Council Study Session
City Hall Council Chambers
July 24, 2023

CITY COUNCIL MEETING
City Hall Council Chambers
July 24, 2023

d. Resolution Ratifying the Approval of the Preliminary and Final Plat for NORTH 100 BUSINESS PARK ADDITION and Authorizing Final Plat Recording

SHEET NUMBER
L100

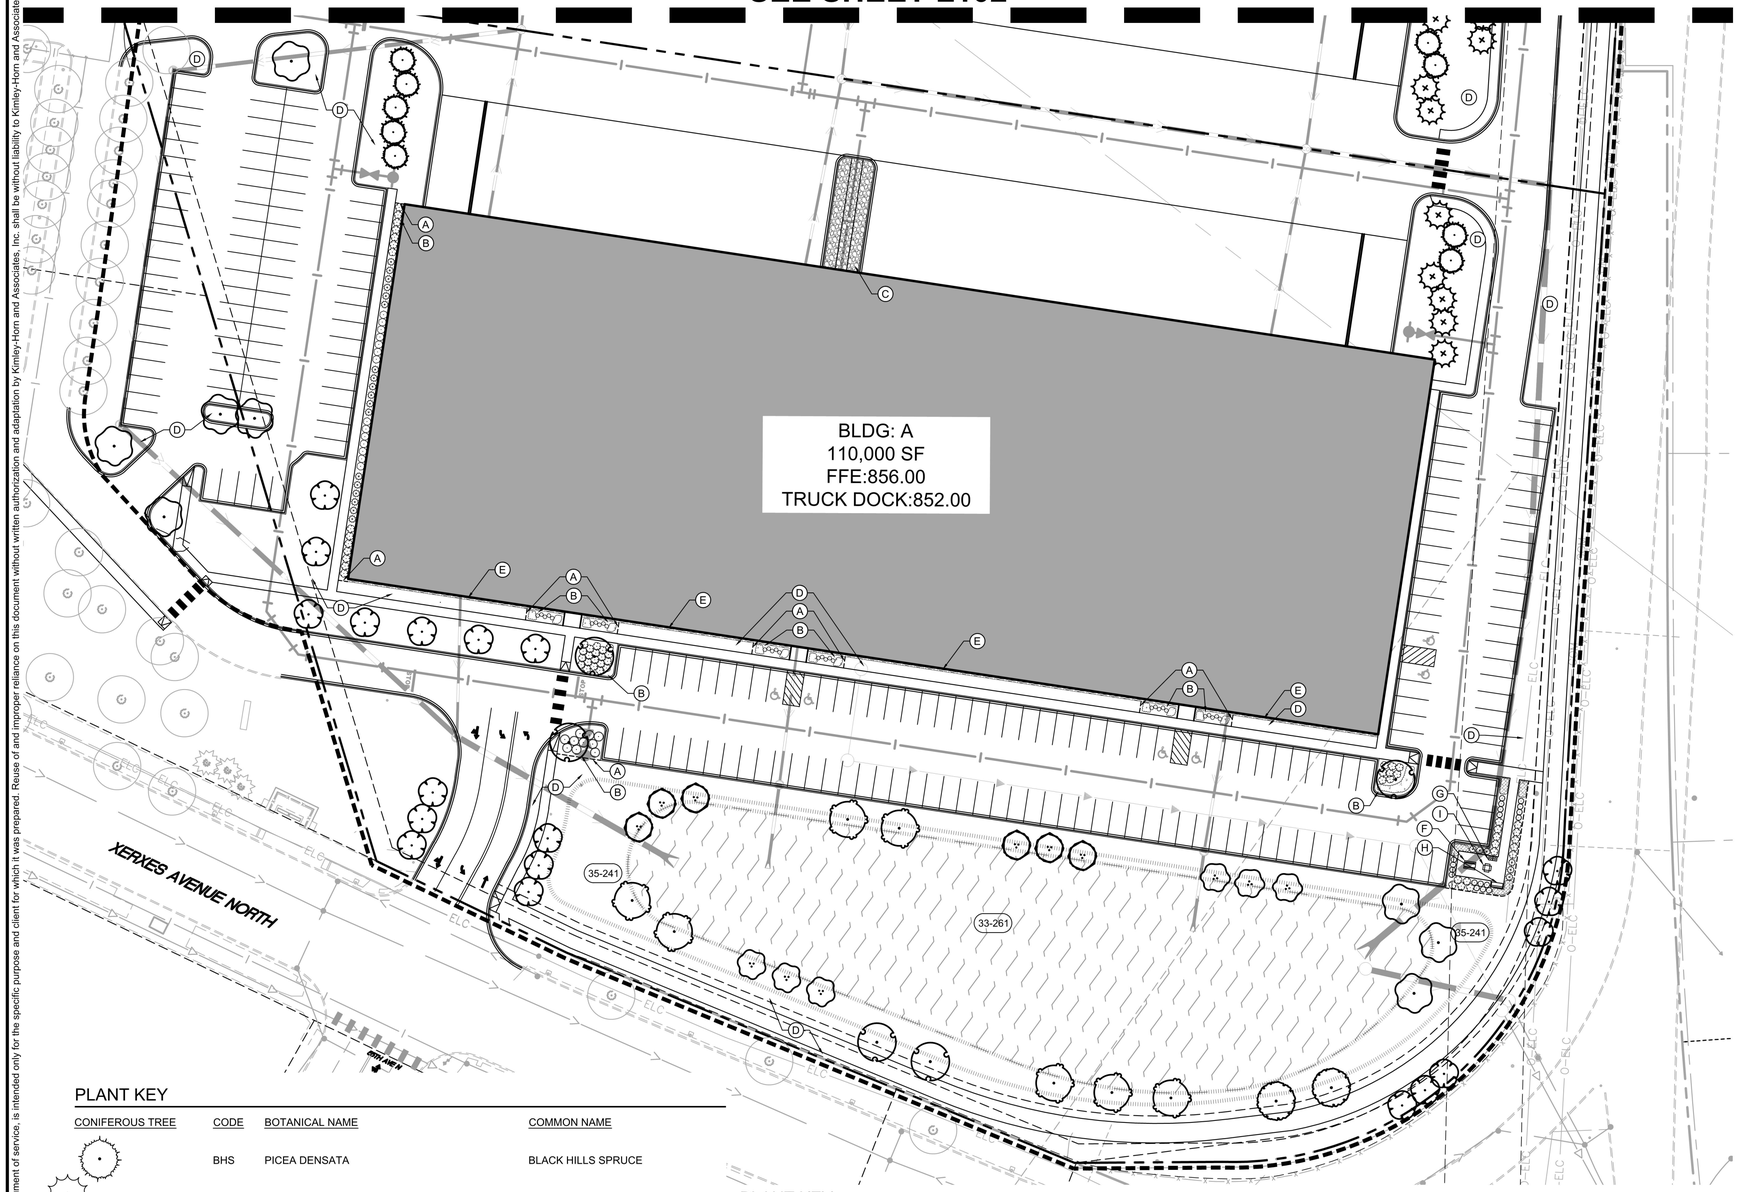
Subject Property's adjacency to a retail shopping center, City staff calculated the landscaping assuming the "Office/Industrial" use. It should be noted that the Overall Landscaping Plan (Sheet L100) clearly indicates an assumption of "Light Industrial," which has lesser requirements for landscaping. Assuming an approximately 15-acre site, the Subject Property would have to accrue 990 points. (2 acres * 90 + 8 acres * 70 + 5 acres * 50 = 990 points).
